Addendum D1

re: **SB885F – Watershed & SB885 Bridge Apartment Interior Upgrade**
Indiana University South Bend
 IU Project #20250140

issue date: **April 1, 2026**

2 Watershed Second Floor Plan - Base Bid
1/8" = 1'-0"

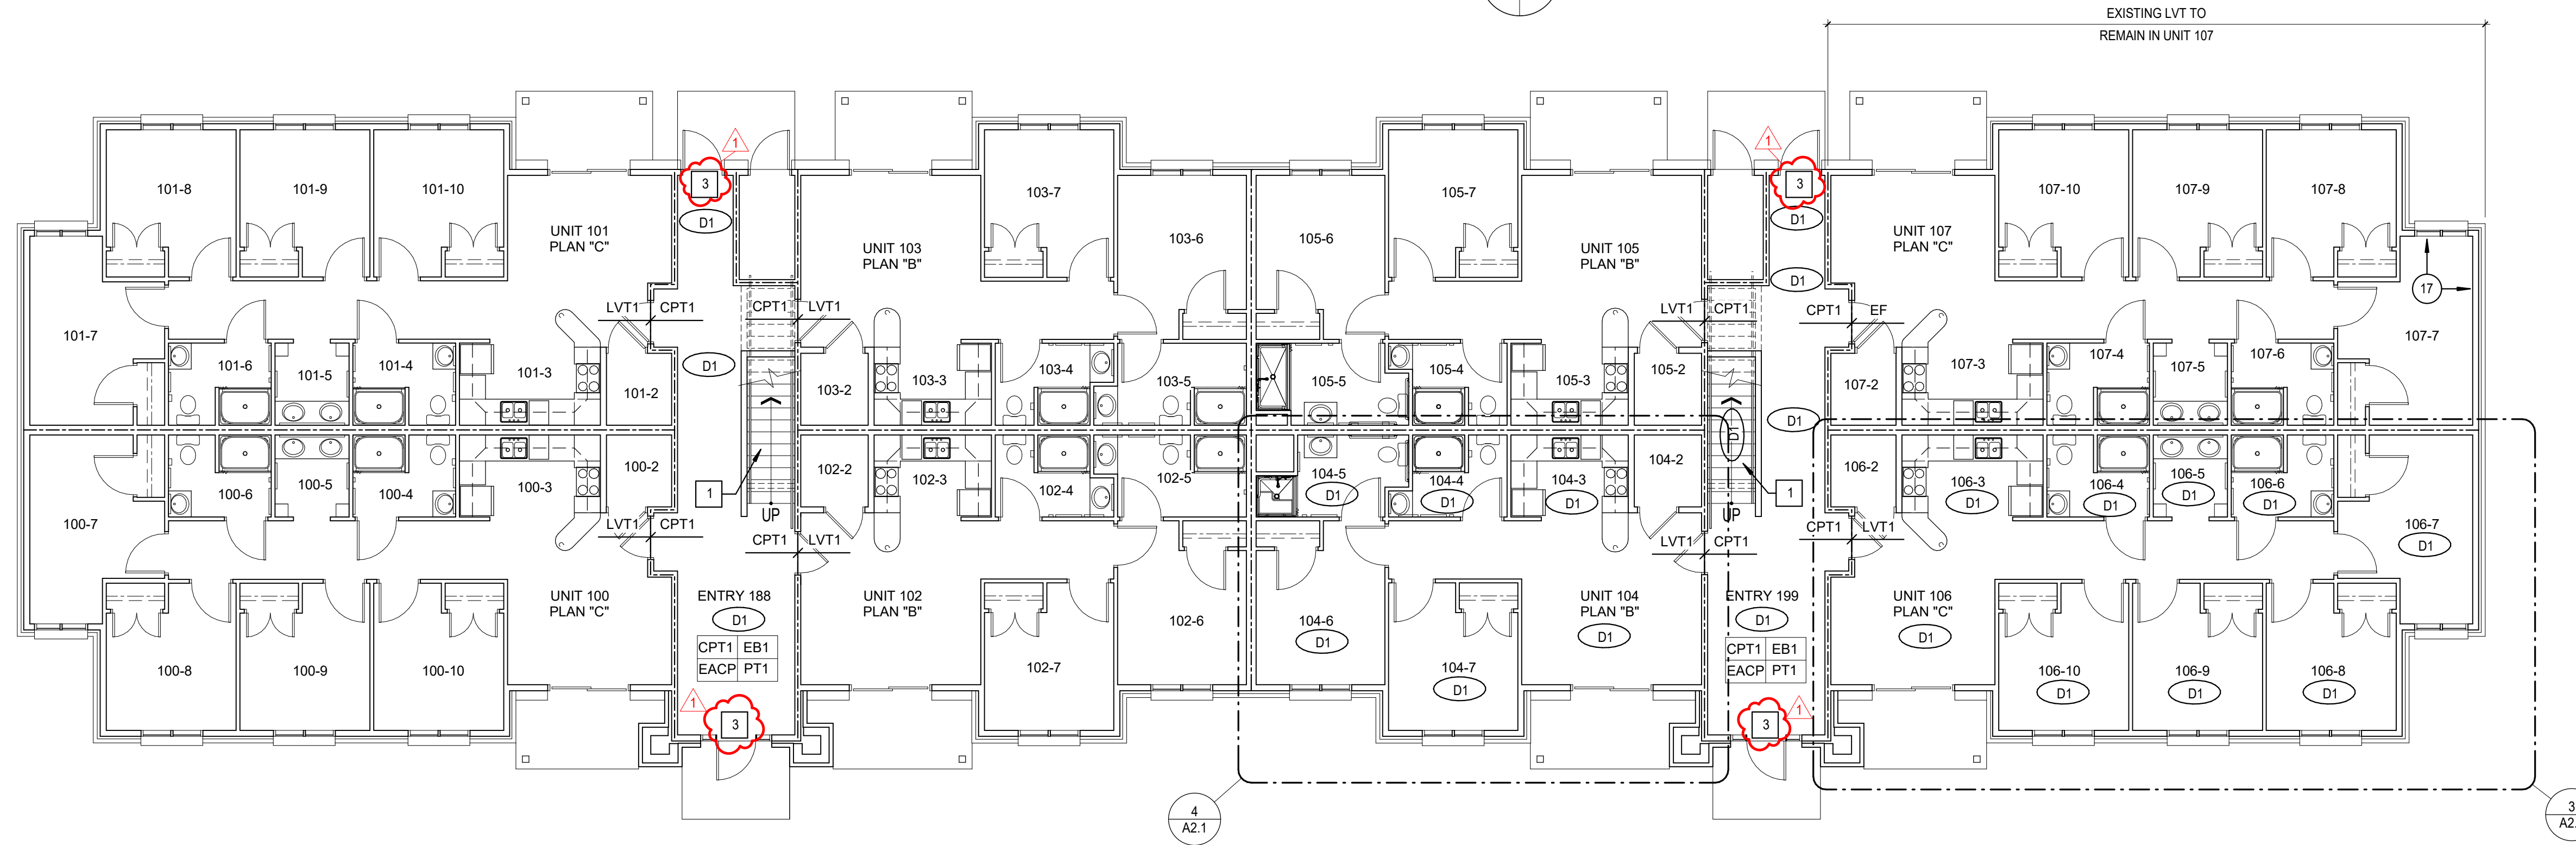
A1.07	DRAWING A2.2 (Drawing Reissued)	<u>CHANGE:</u> Sheet A2.2 reissued to change Specific Floor Plan Note #17.

Bridge House - First and Second Floor Plans - Alternate #1

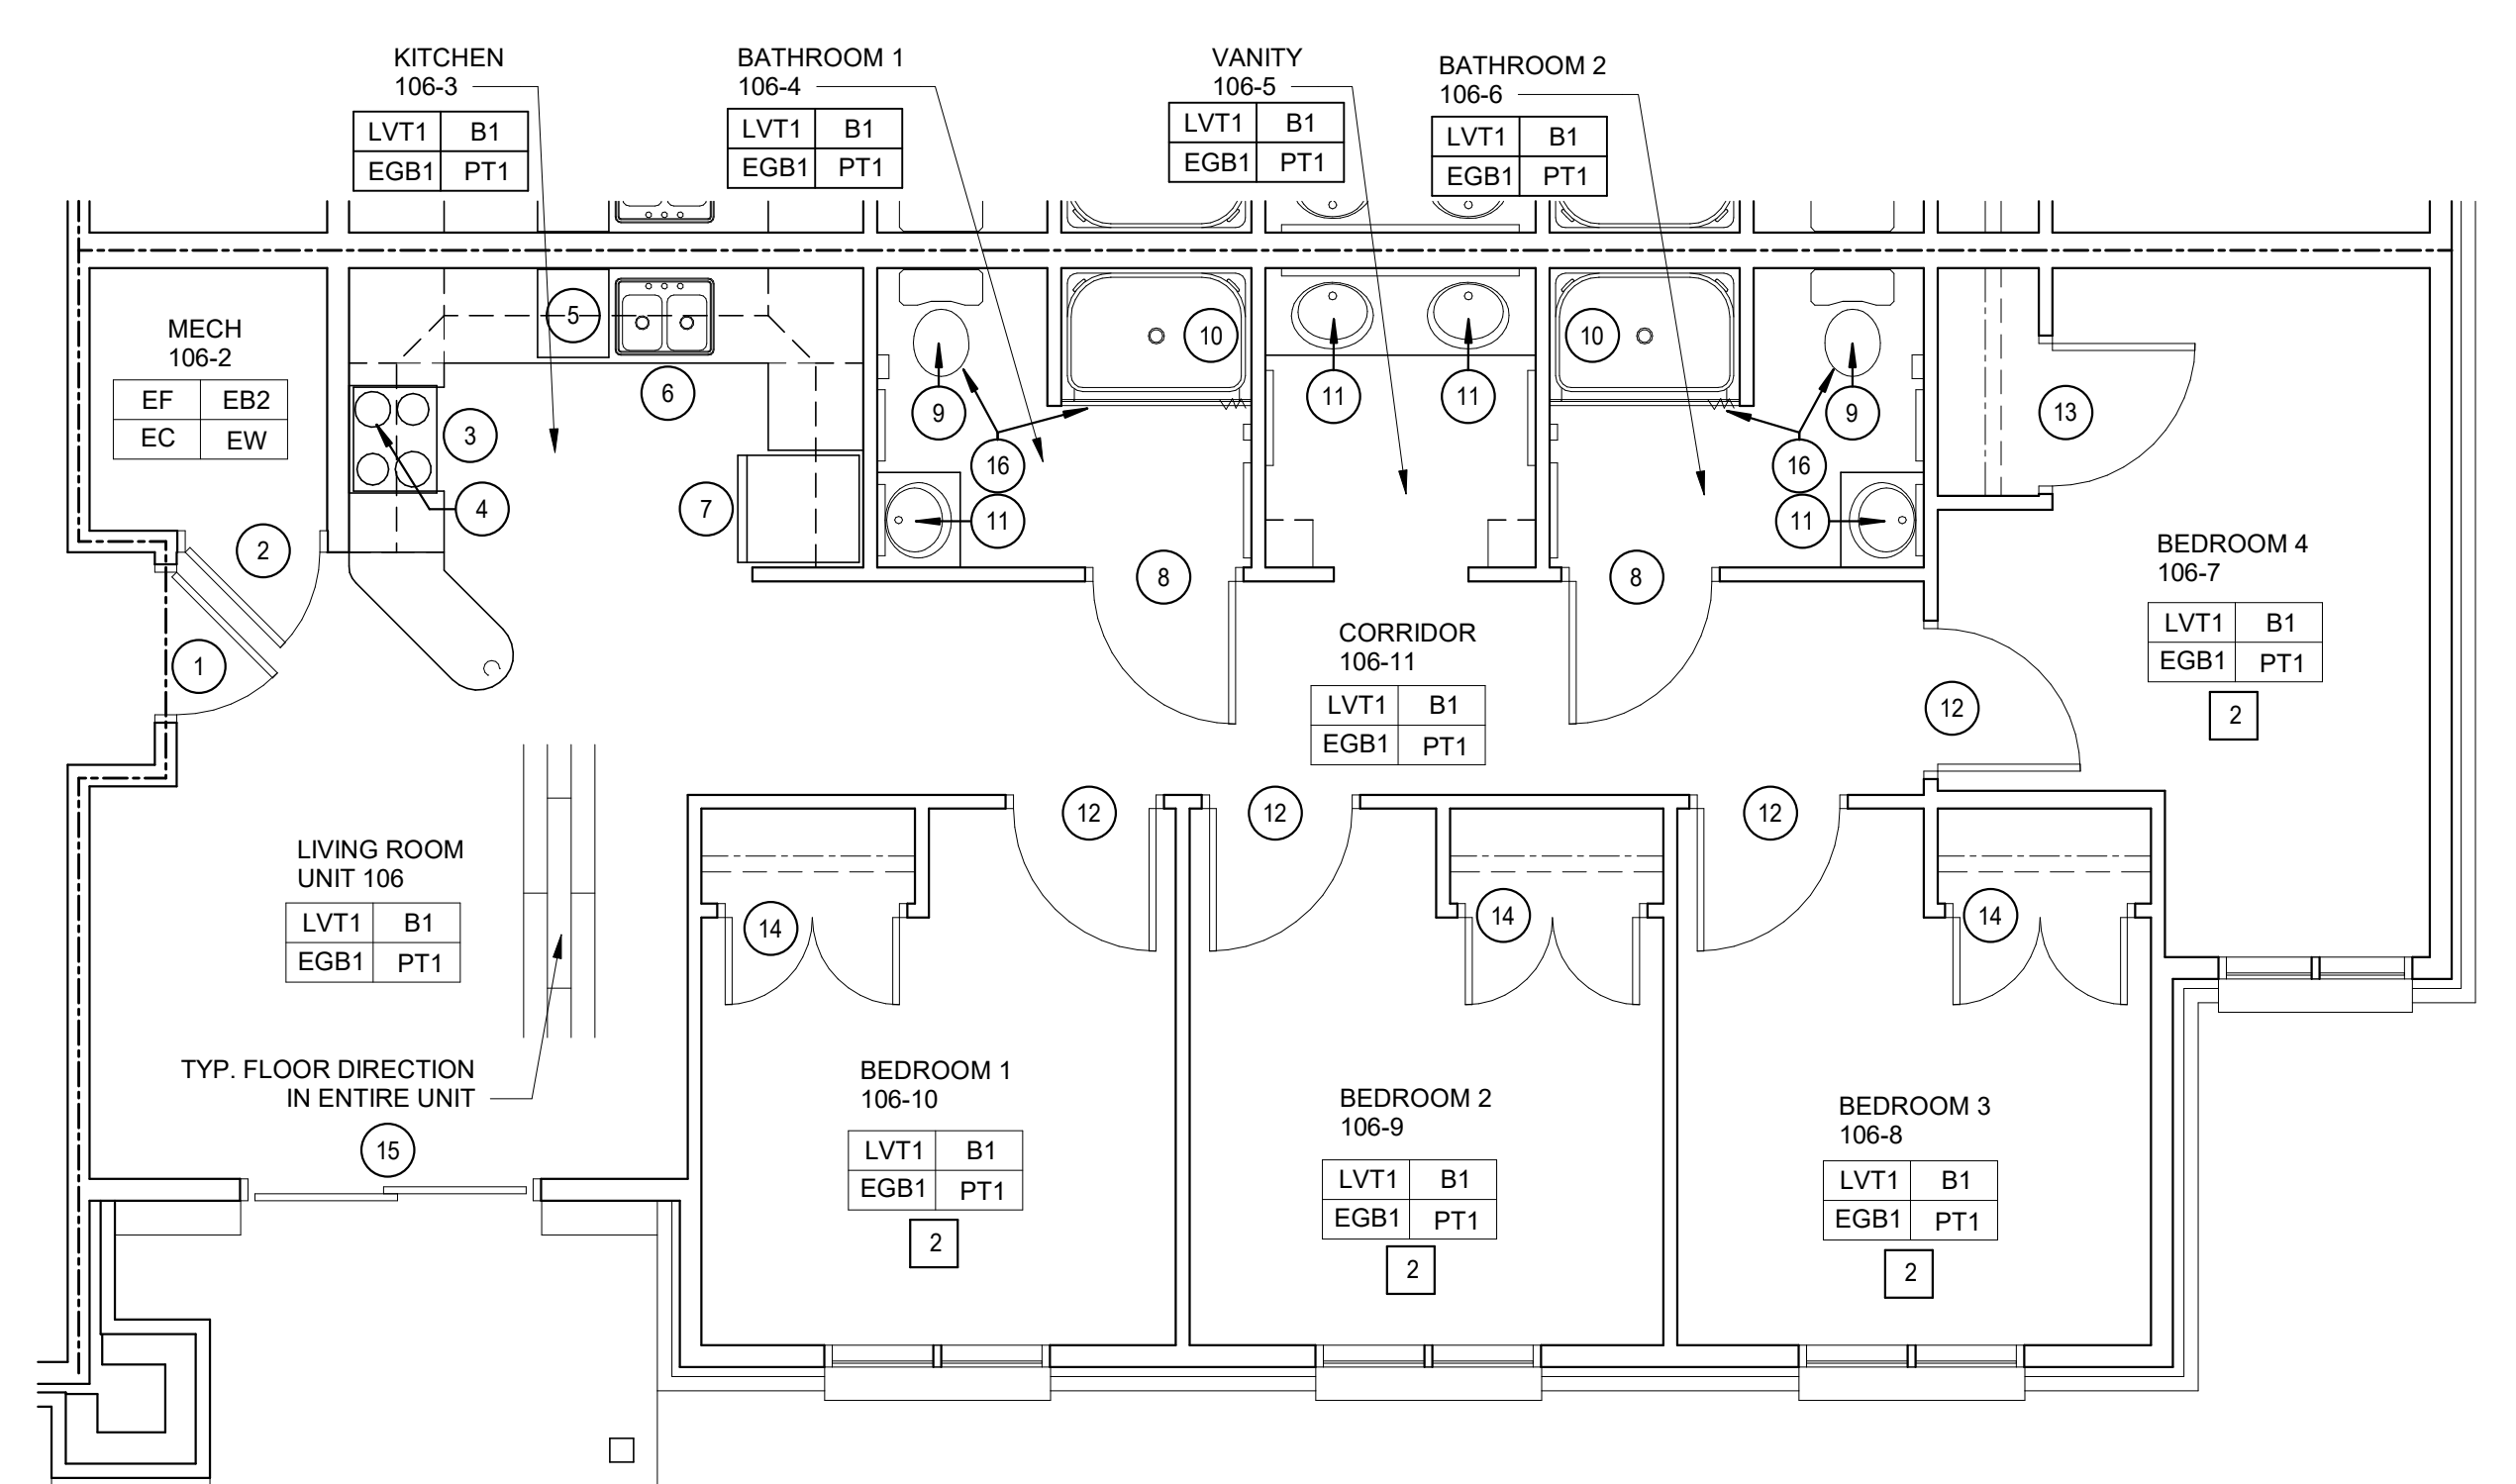
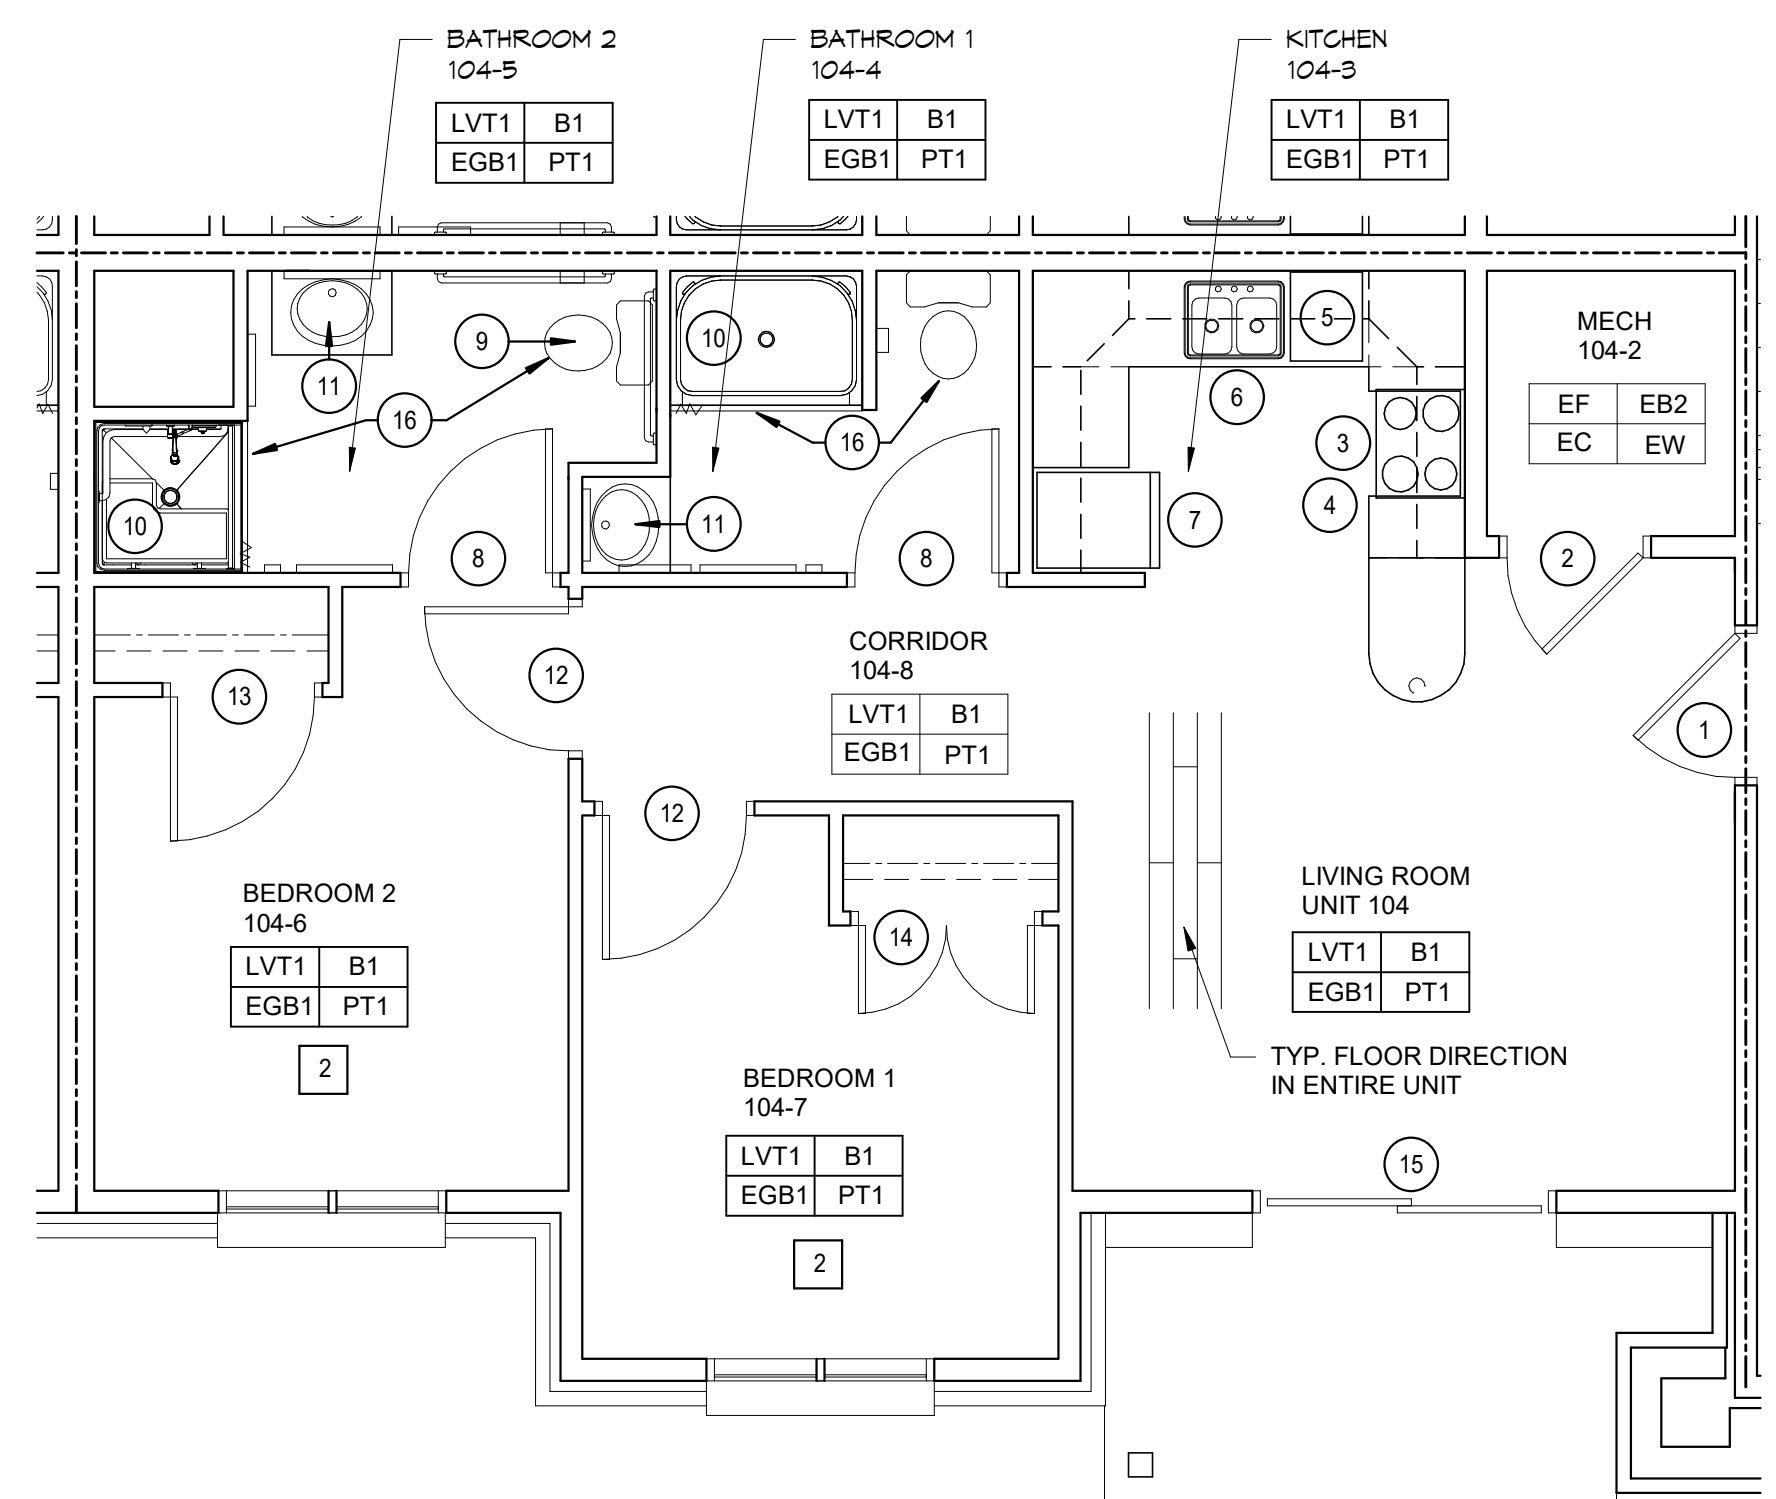
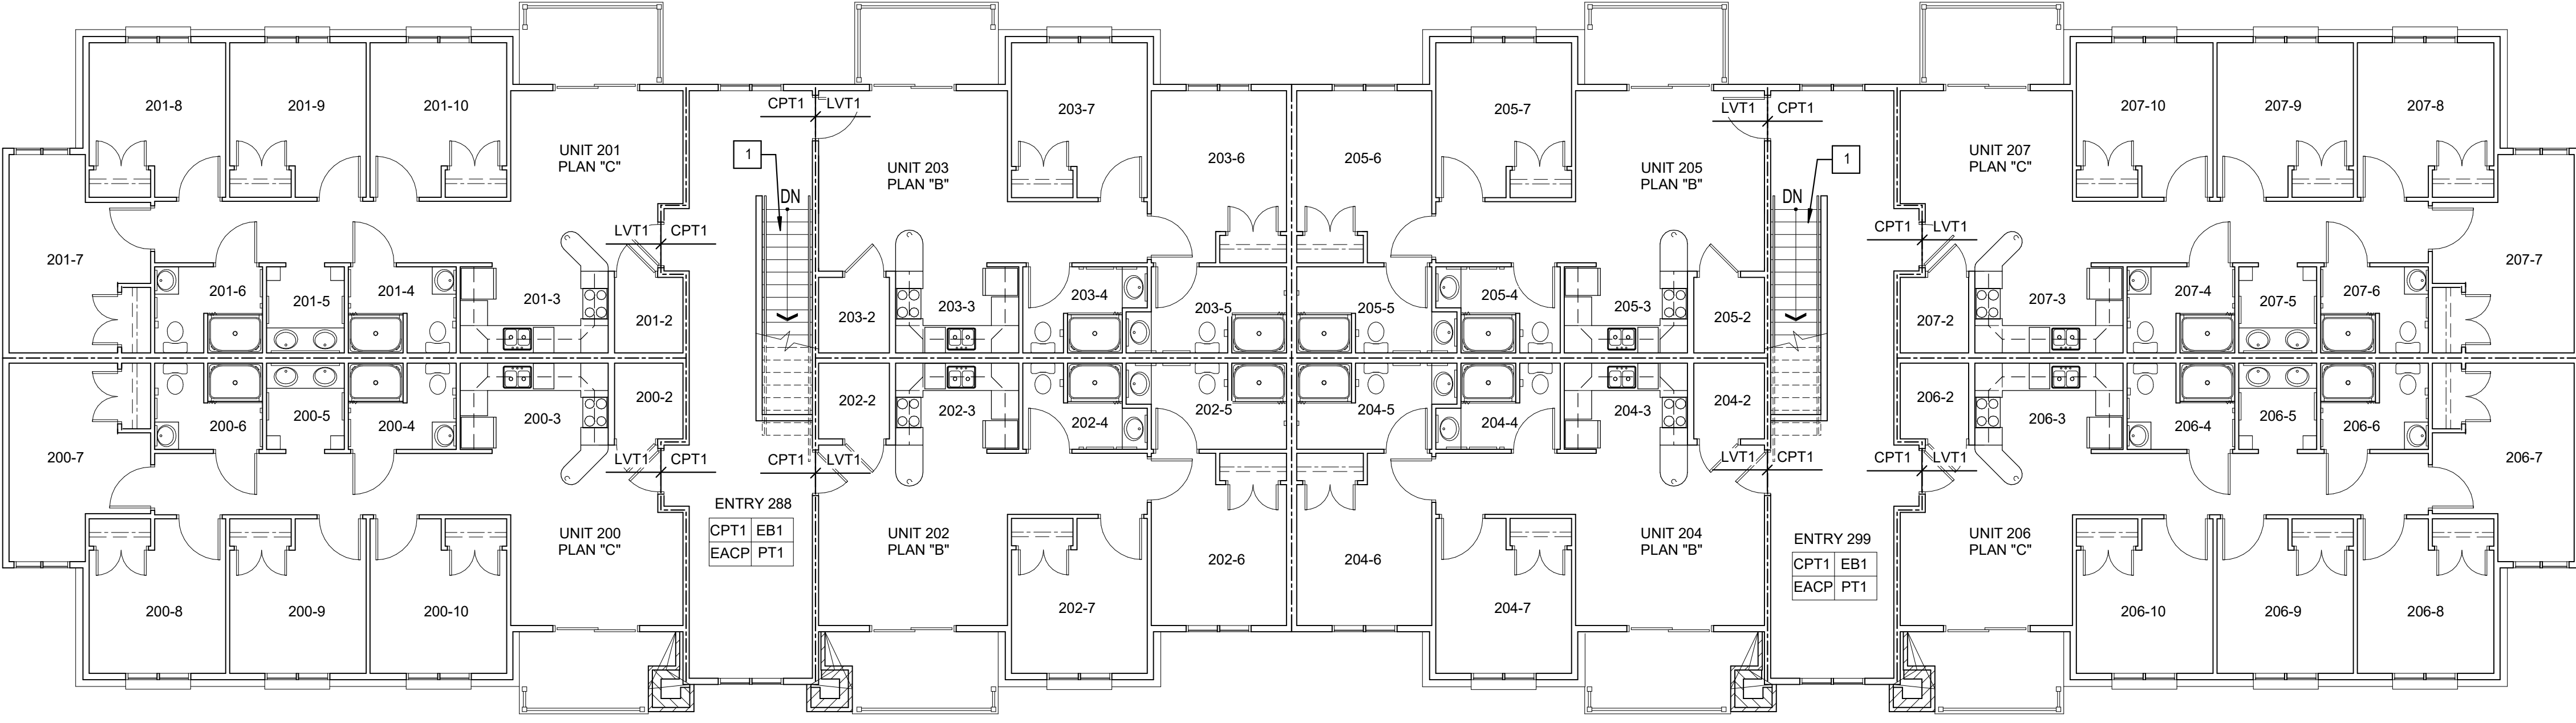
A1.08	DRAWING A2.2 (Drawing Reissued)	<u>ADD:</u> Sheet A2.2 reissued to add specific Floor Plan Note #18; to add Specific Finish Remark #3; and to add clarification on paint finish to receive enamel paint on exterior metal doors and frames.
-------	--	---

RST1 - JOHNSONITE	EACP - EXISTING ACOUSTICAL CEILING TILE
COLOR: #20 CHARCOAL WG *COLORMATCH	AND GRID TO REMAIN
FINISH: HAMMERED	
DOORS (UNIT PRICES 1, 2, 8, 12, 13 & 14)	
PT = PAINT COLOR	
PT1 - SHERWIN WILLIAMS	
COLOR: IVORY LACE	
NUMBER: SW7013	
FINISH: ENAMEL PAINT FOR EXTERIOR METAL	
DOOR & FRAMES
